**Technical Information
Version Update**

July 10, 2006

JX6-CON-Move Modifications from Version 3.001 to Version 3.035

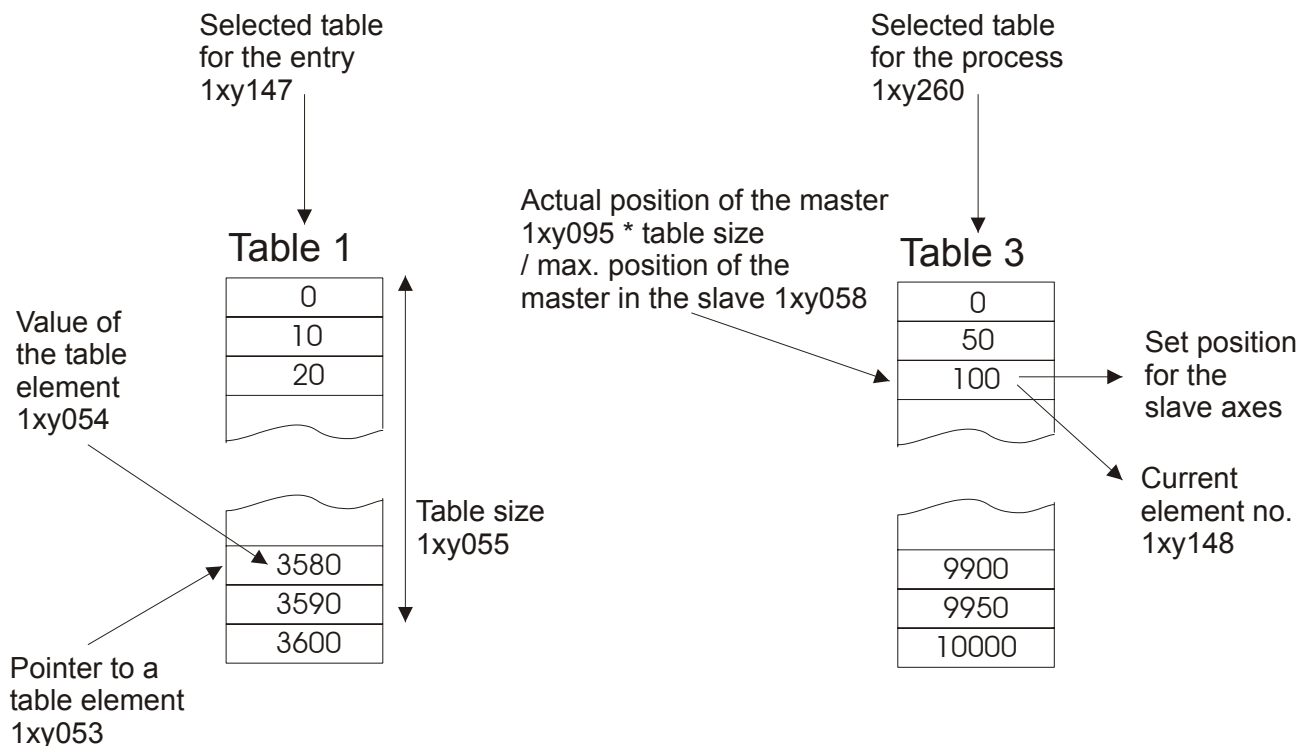
- (3.004) Starting from this version, the tables can be entered and processed separately. This means that it is possible to enter another table while a table is being processed. The new register 1xy260 serves to select the table for the process.

The following diagram illustrates the entry and process of various tables:

As in previous versions, different table sizes are allowed. As long as register 1xy260 is not written, register 1xy147 is used as selected table for the process.

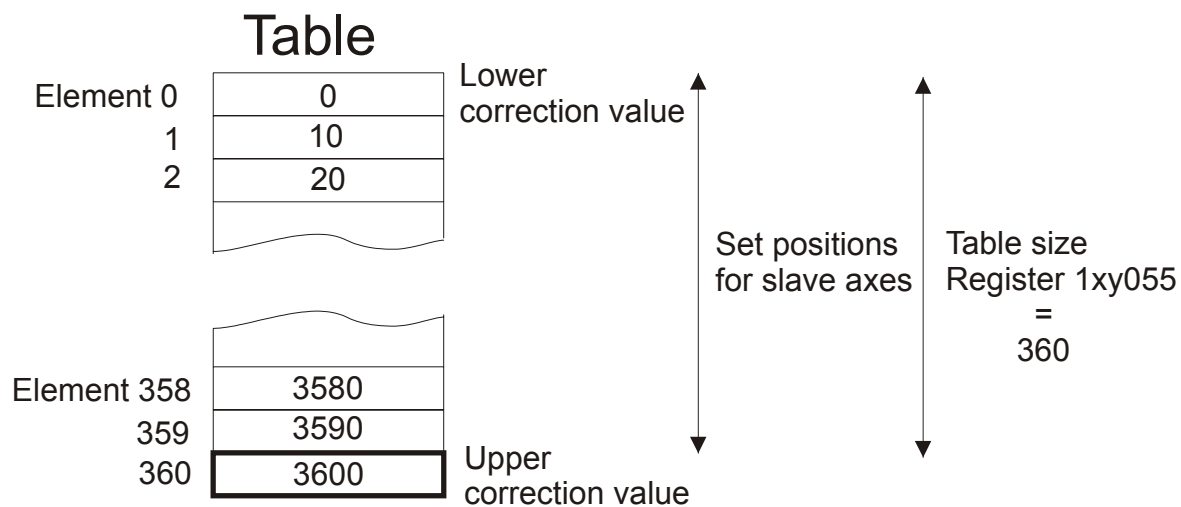
- (3.002) When recording the actual position in JetSym or Sympas oscilloscope mode, the values might have been incorrect.
- (3.003) Starting from version 2.900, an error might occur when creating a table if a table was written before using a too extensive table pointer.
- (3.004) Starting from version 2.900, the correction value during table mode overflow applied to the last table element. Starting from this version, the correction value must be entered again as additional element:

The correction value in case of table overflow is calculated as follows:

Correction value

= Value of the table element (register 1xy055) – value of the table element (0)

= 3600 increments – 0 increments = 3600 increments
